Peer Review of Greater Wellington Flood Protection Assets

By Horizons Regional Council 19 & 20 June 2008

Report prepared by Paul Joseph and John Eyles, September 2008

2.3.1 Ava to Rail bridge Capital works

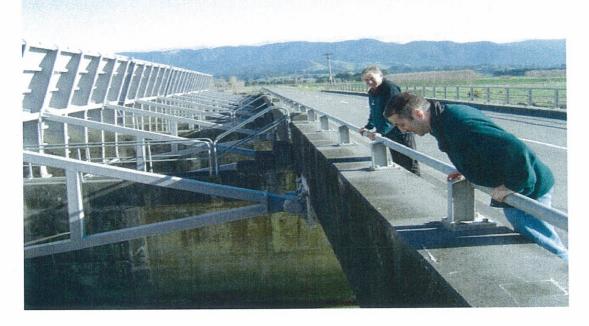
This \$5M capital project has recently been completed. HRC were very impressed by the standard of the works at this site. The walkways and rock complemented each other aesthetically and provided a sound engineering solution to bank erosion in this reach. Interesting to note that rock was barged in from the South island, and how smoothly this operation went, showing good project management skills by GW.
